STAFF RECOMMENDATION 1408 Paris Avenue October 18, 2017

Application: New construction- addition and detached accessory dwelling unit; Setback determination

District: Belmont-Hillsboro Neighborhood Conservation Zoning Overlay

Description of Project: Application is to construct an addition that is taller and wider than the historic house and to construct a detached accessory dwelling unit, which includes setback determinations for the rear and left side setbacks. The plan also proposes changes to the historic house including changes to the front stoop covering.

Figure 3: Images from early plans books show that the Minimal Traditional style favored small covered stoops over the large porches more typical of turn-of-the-century styles.

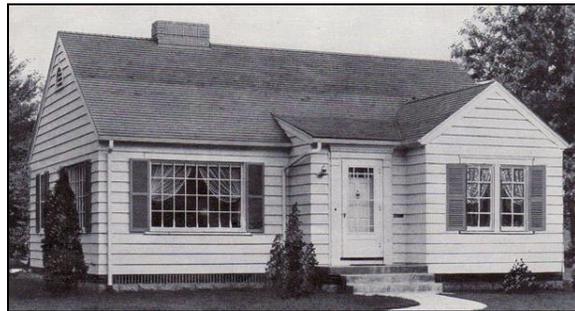
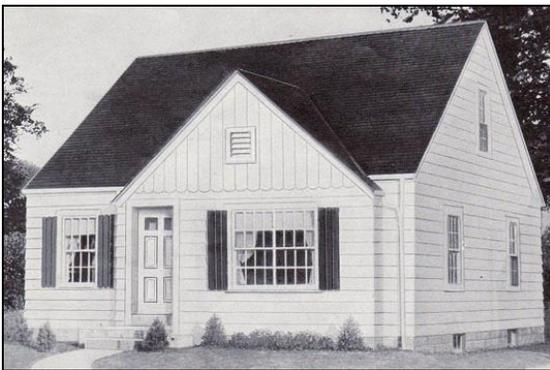
The earliest photo known, from 1968, (Figure 2) shows the existing covered stoop configuration and side porch. There is no physical evidence of a larger stoop covering with a different pitch than the existing covering. The side porch seen in 1968 is typical of the era of construction, which is c. 1930 (Figure 3).

Porches and primary entrances are typically “character defining features” which the Secretary of Interior Standards requires be preserved. For this reason, alteration of the existing porch roof does not meet Section V.2 for demolition.

Staff recommends disapproval of the alterations to the existing stoop roof and brackets and to the windows on the left side façade, finding that the alterations do not meet Section V.1 for appropriate demolition and meet Section V.2 for inappropriate demolition. Staff recommends approval of the request to replace the existing siding and the proposed window replacements that do not require alteration of dimensions with the condition that the existing window casings be retained, finding that these alterations meet Section V.1 for appropriate demolition and do not meet Section V.2 for inappropriate demolition.

Figure 4 & 5 show the enclosed rear porch that is to be demolished.

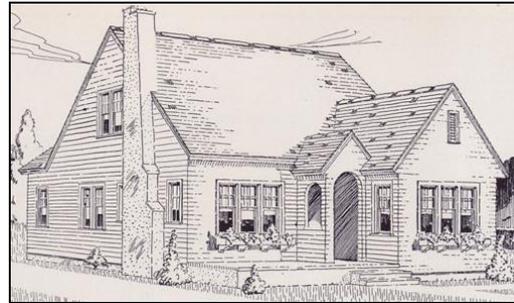
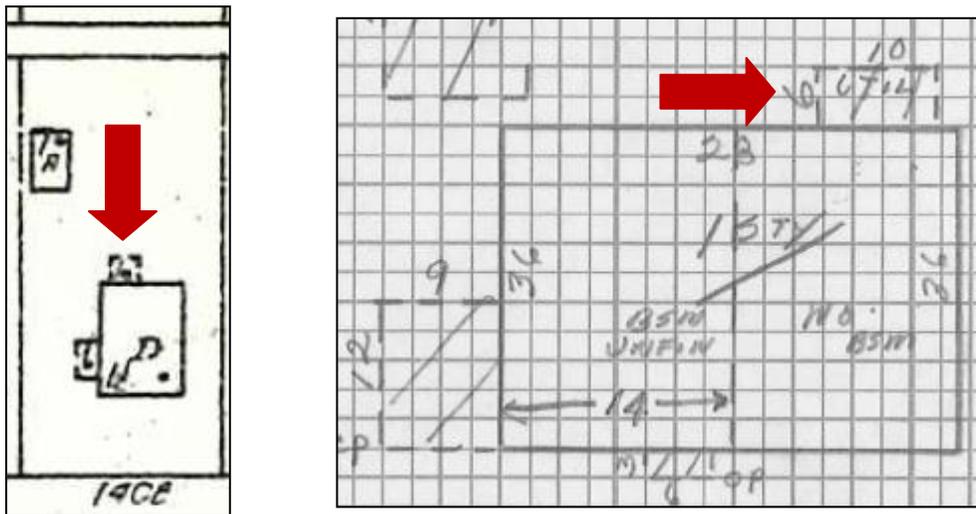
The applicant also proposes to demolish an existing enclosed rear porch (Figures 4 – 5). The addition was likely enclosed sometime after 1968 as both the 1957 Sanborn Map (Figure 6) and the 1968 Property Assessor card indicate an open porch on the rear (Figure 7). Staff finds that the addition’s date of construction, location at the rear of the house, roof form, materials, and design do not contribute to the historic character of 1408 Paris Avenue or to the Belmont-Hillsboro Neighborhood Conservation Zoning Overlay.

ARCHITECTURAL SITE PLAN

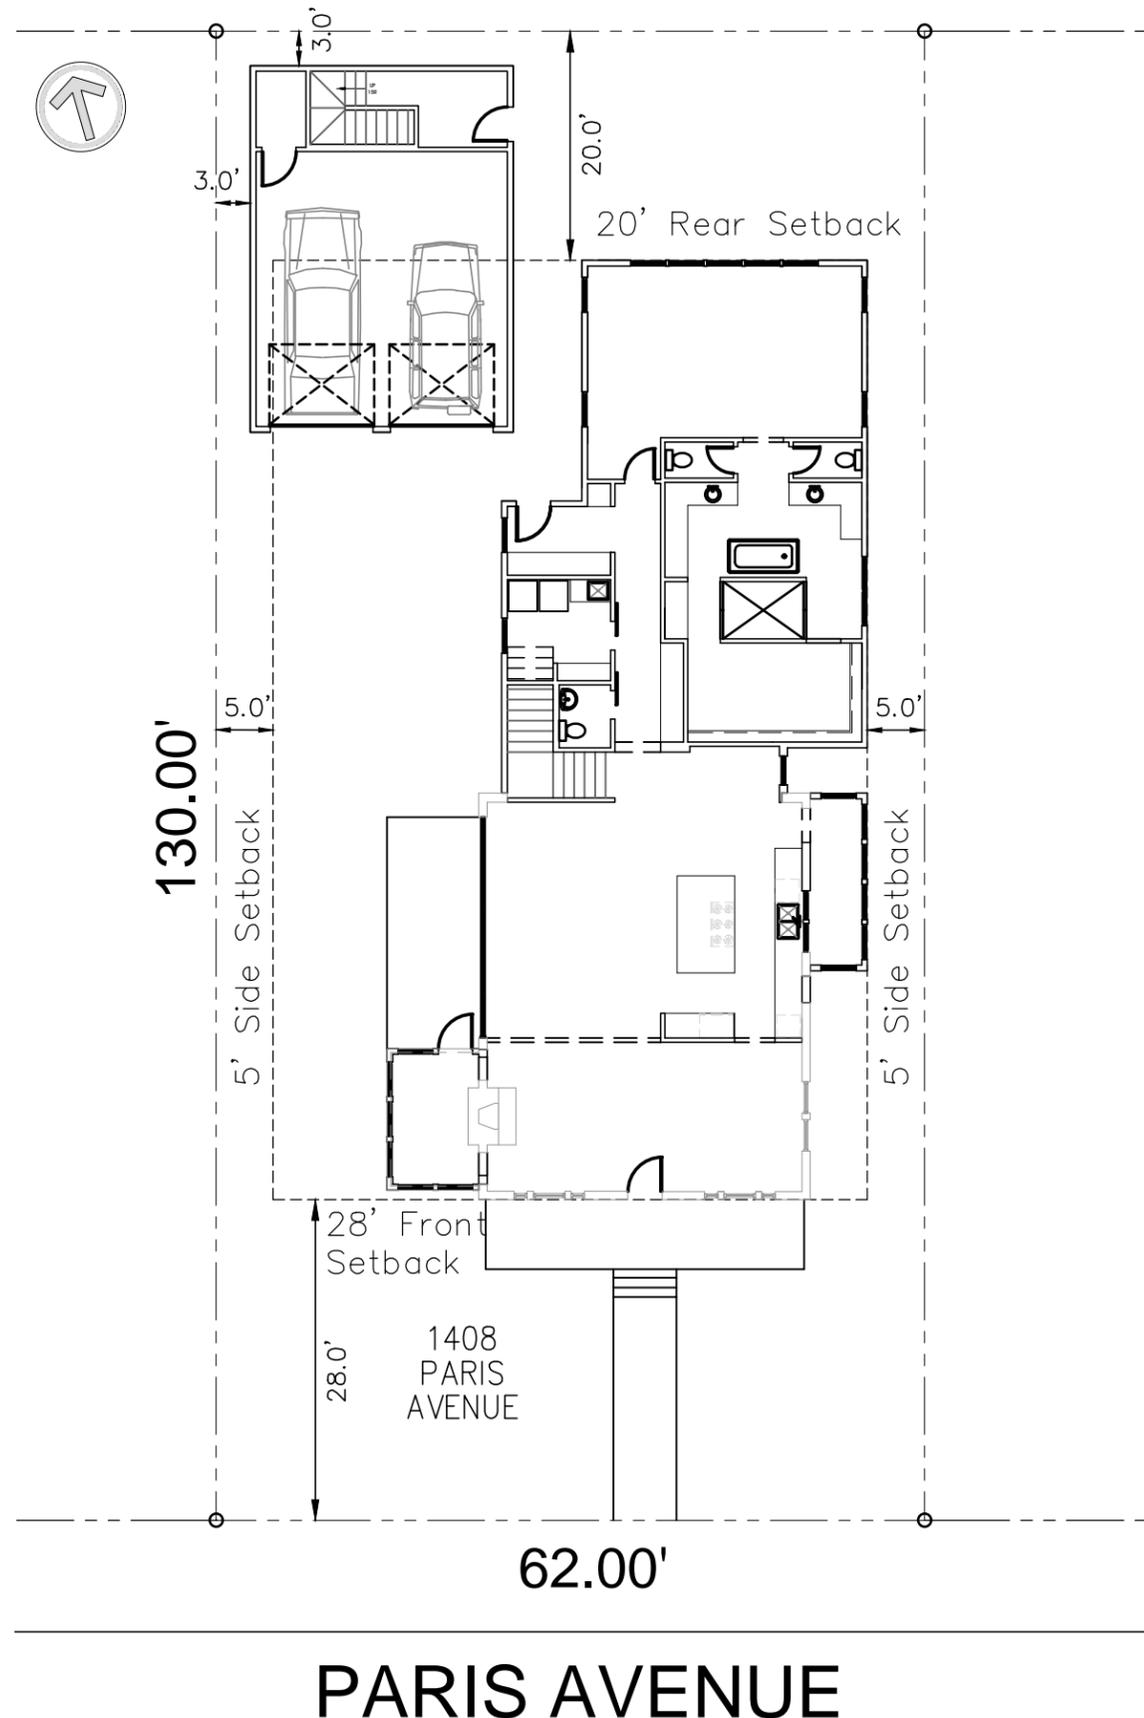
1. The left side setback be increased to five feet (5');
2. The distance between the house and DADU be increased to ten feet (10'); and
3. The restrictive covenant for the DADU be submitted prior to issuance of the preservation permit.

A1.0

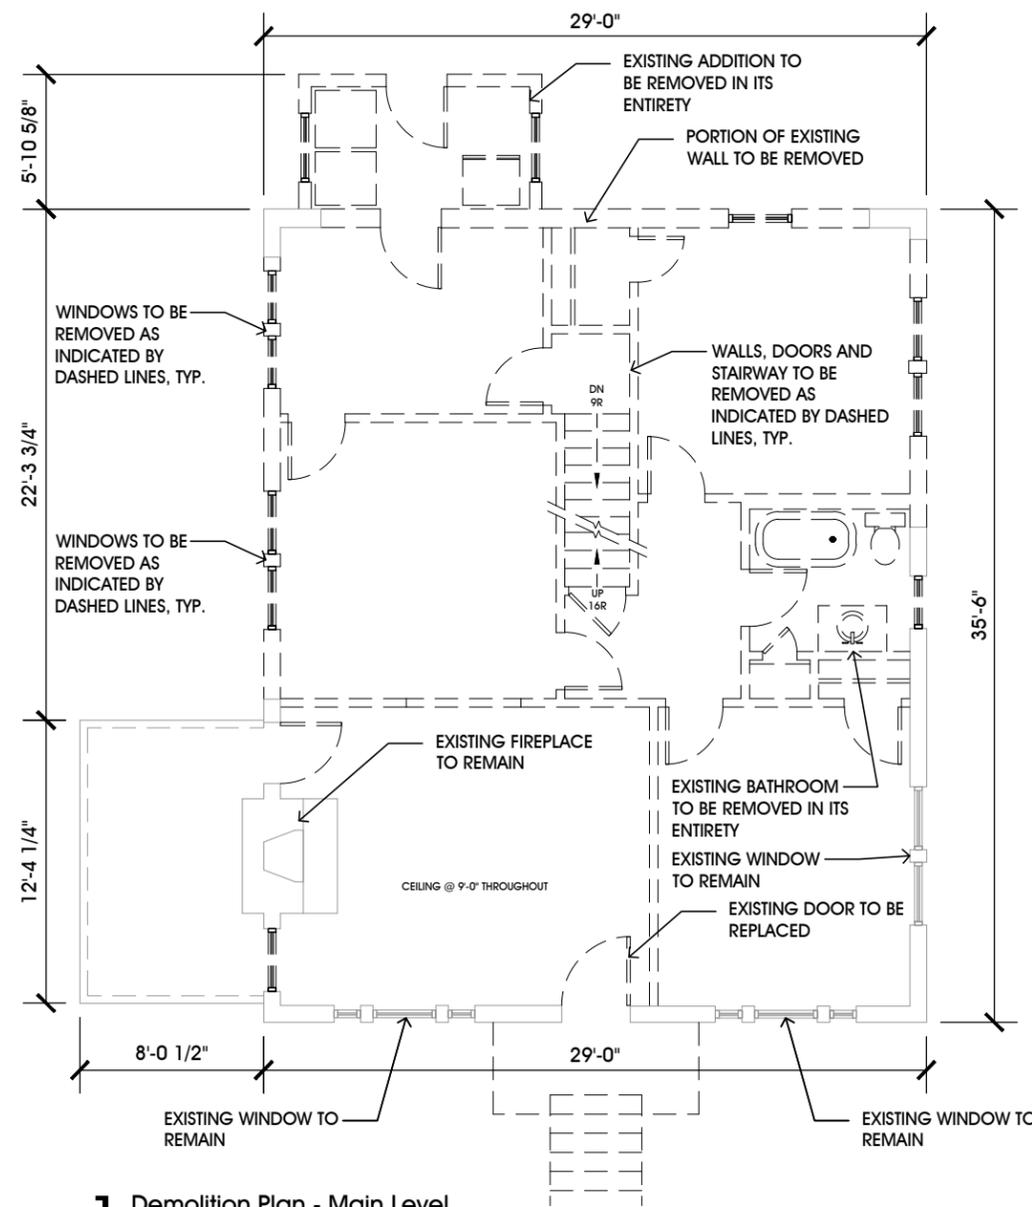
Demolition: The application proposes to alter the existing stoop covering, demolish the existing enclosed rear porch, replace two sets of paired windows on the left side façade with a sliding glass door, and replace the existing siding.
